Health Consultation

HOOKSTON STATION SITE REVIEW
AND APPROVAL OF THE RISK ASSESSMENT

PLEASANT HILL, CONTRA COSTA COUNTY, CALIFORNIA

SEPTEMBER 30, 2006

Figure 2. Trichloroethylene Concentrations in the Uppermost Groundwater Layer, Hookston Station Site, Pleasant Hill, California (1)

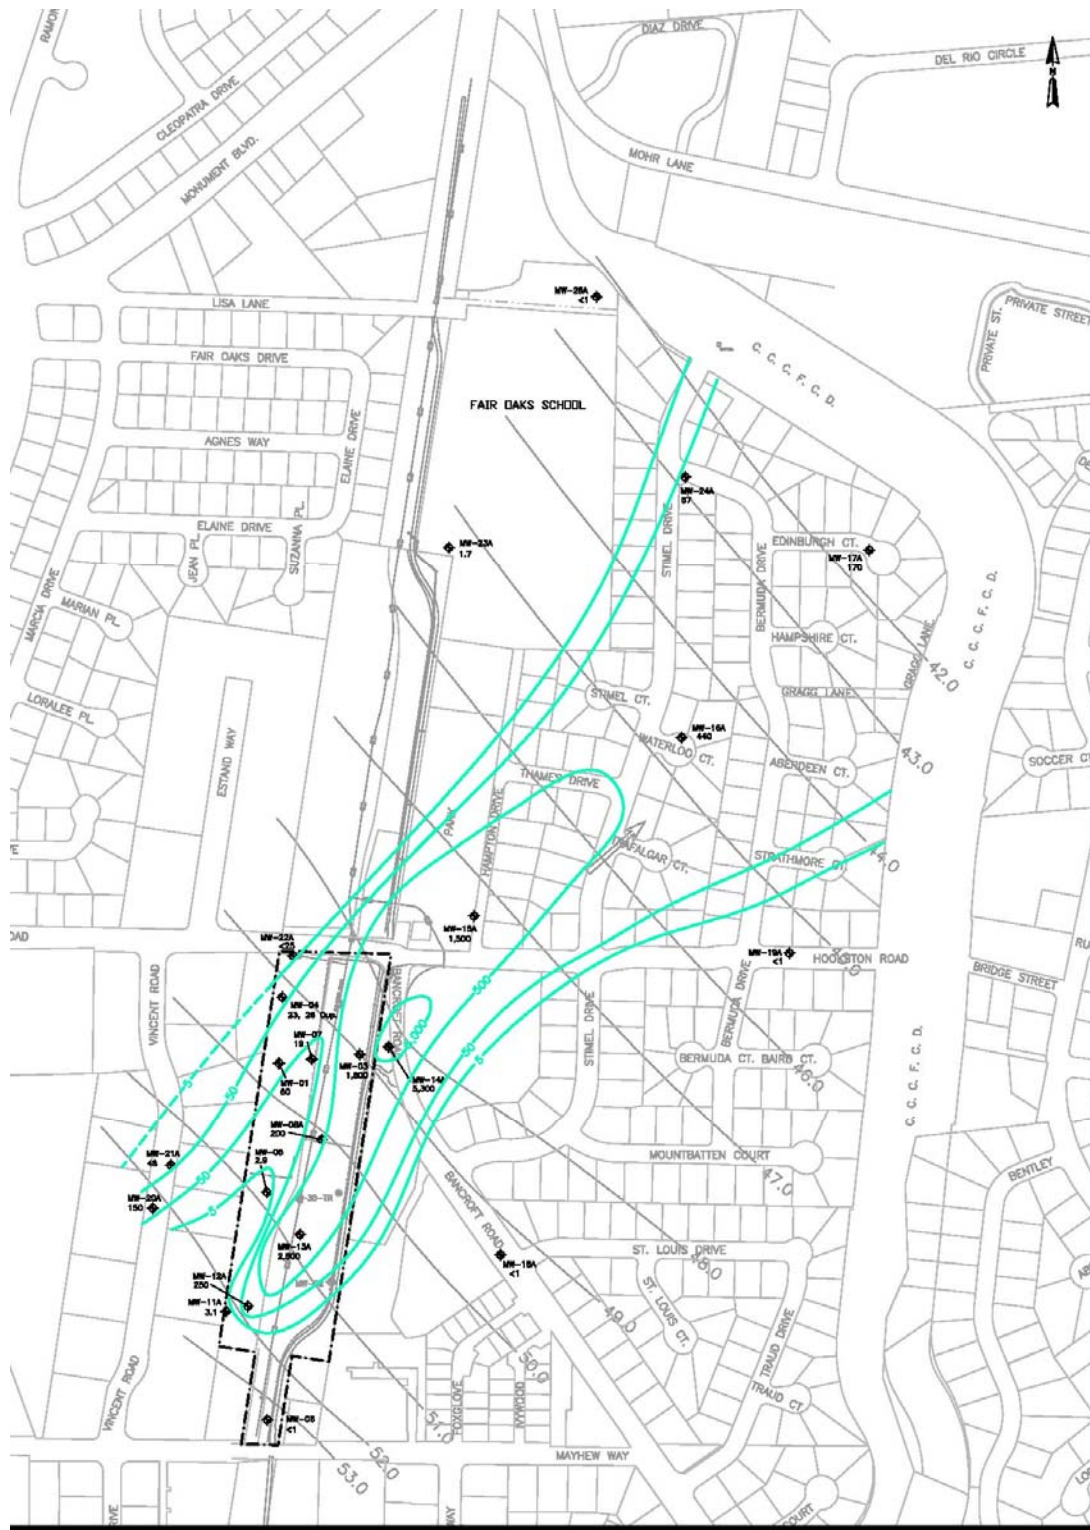
- CDHS found the concentration contour lines for the ground water contamination on the figures in the site documents to be based on limited monitoring wells. CDHS suggested that additional investigations seem warranted.
